INSPECTION REPORT

Permit Number: B2013-9606

Address: 200 Hope St

RE: Stop Work Order – **200 Hope St** – Unsafe Conditions – structural columns basement area

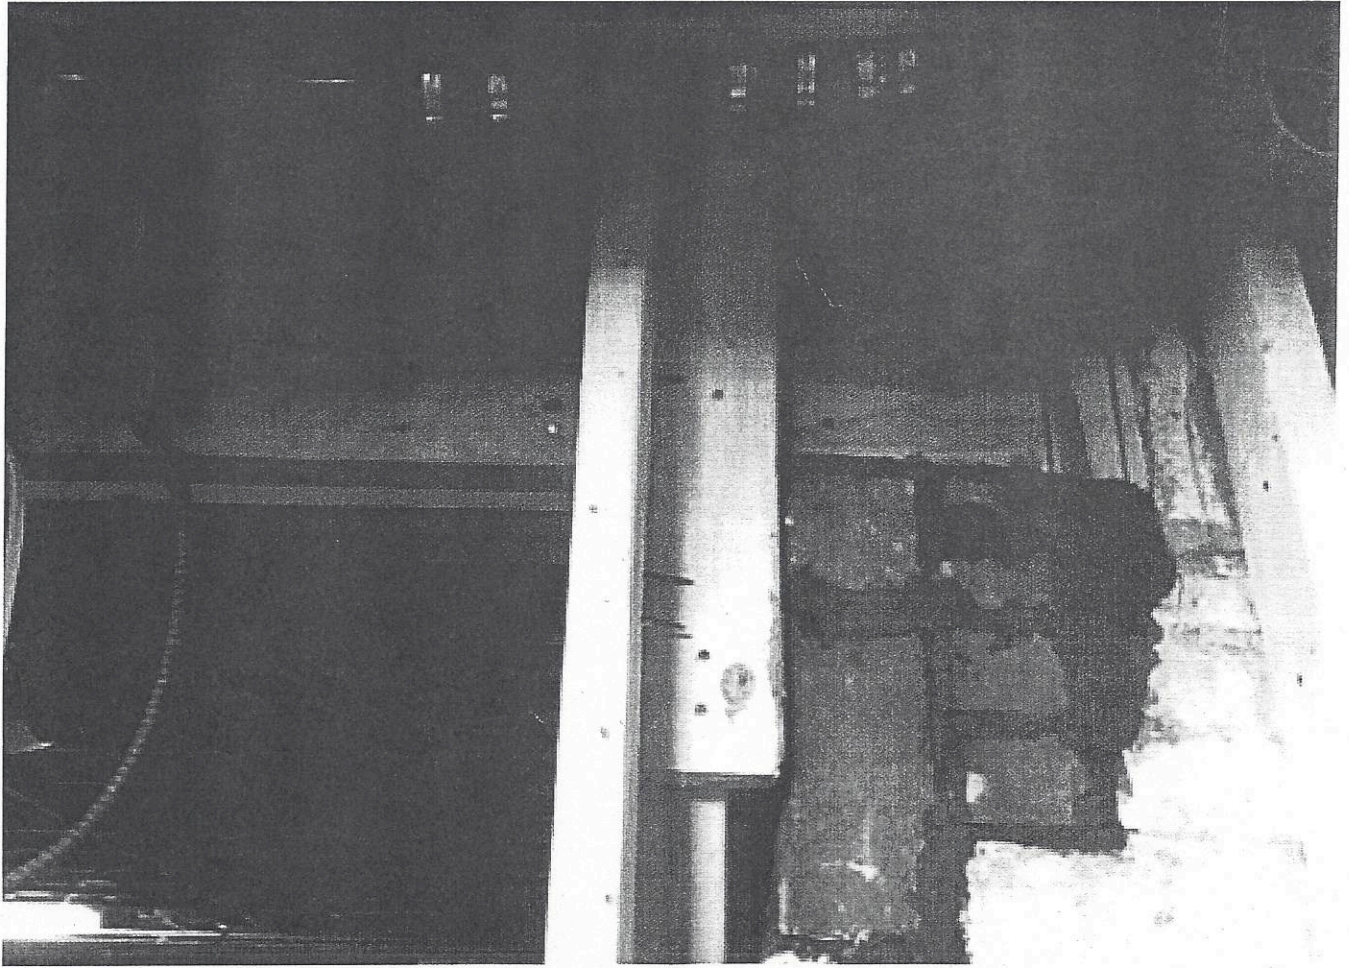
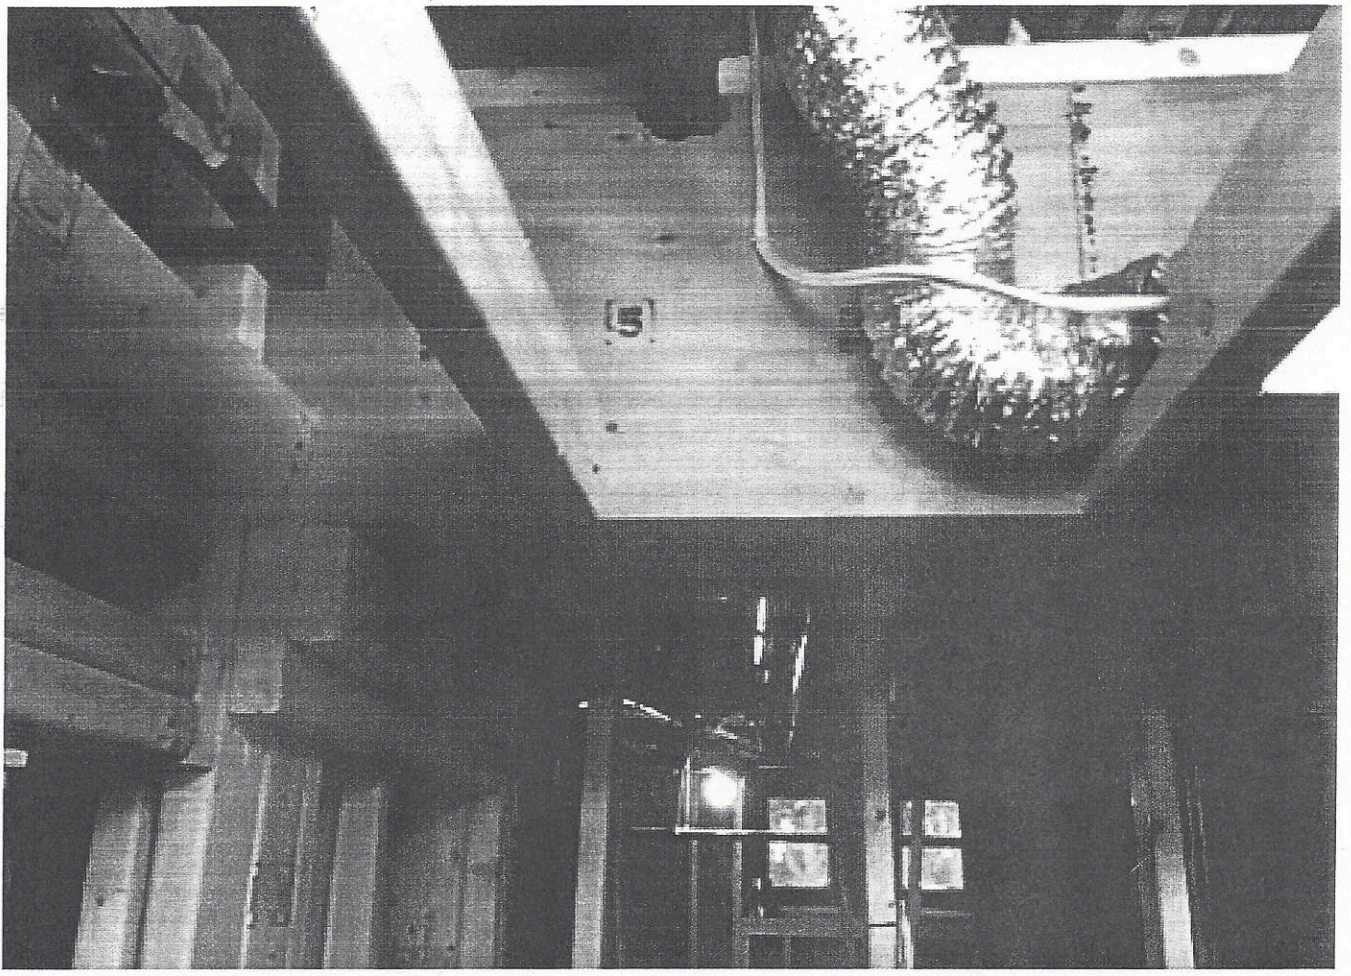
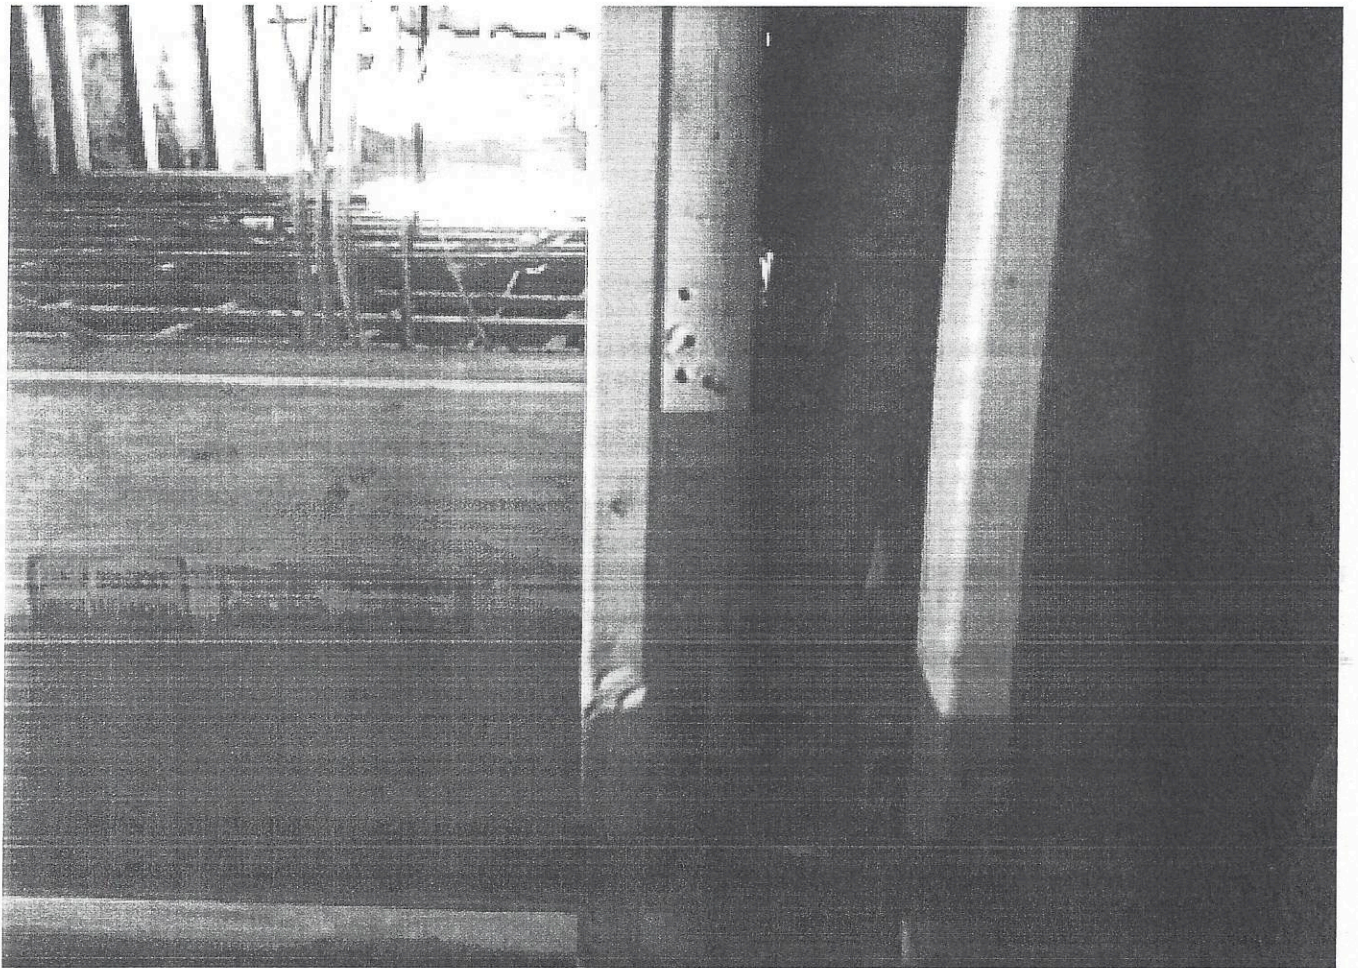
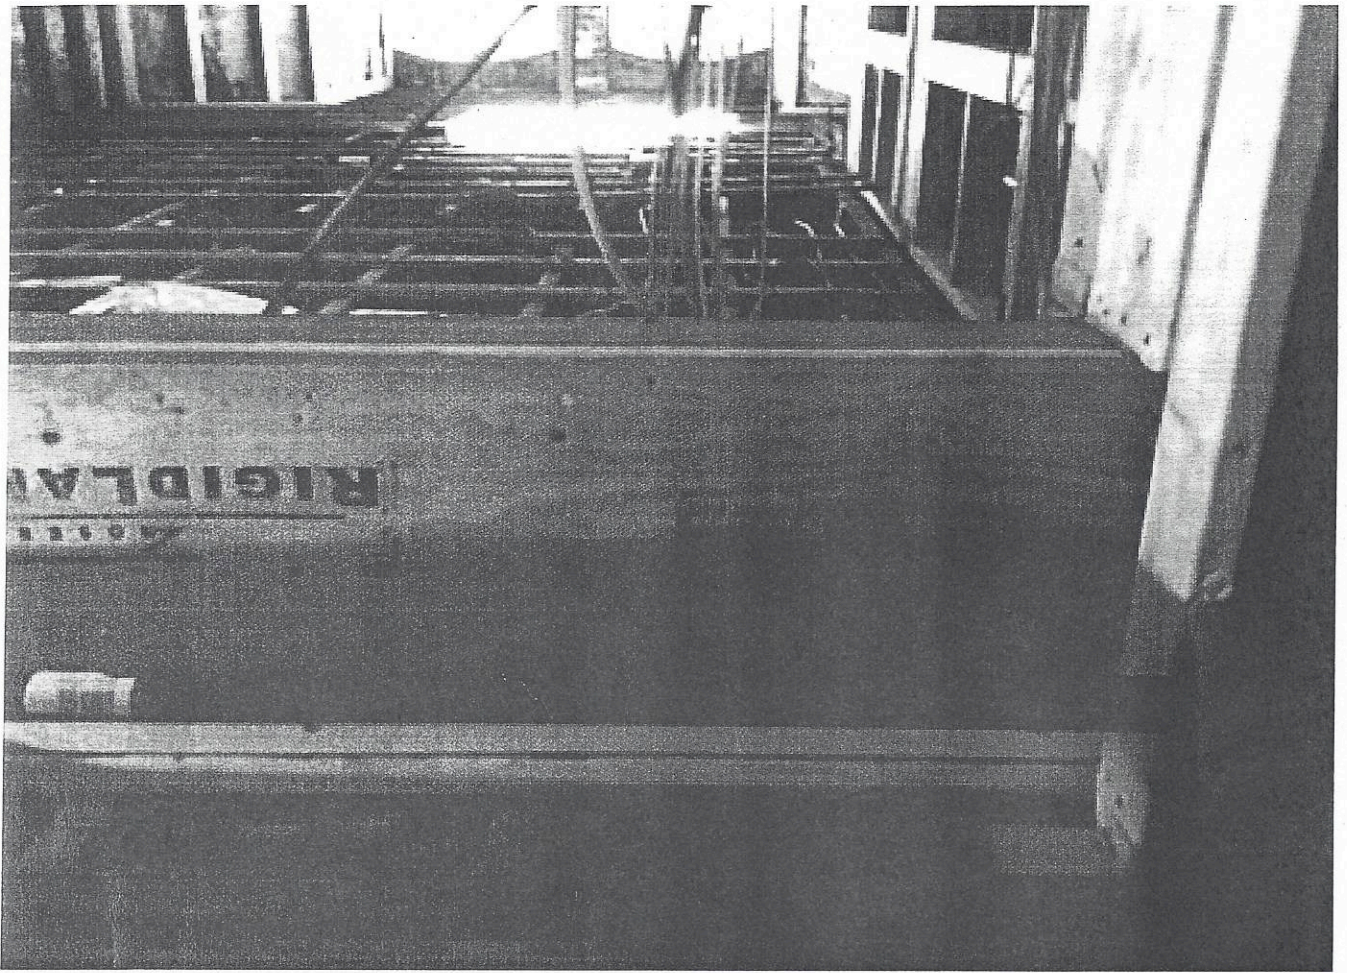
Comments: Columns added to beams.
Gang beams need to be through bolted.
Need details on egress windows, not built to approved plans.
Proper clearance not provided at boilers.
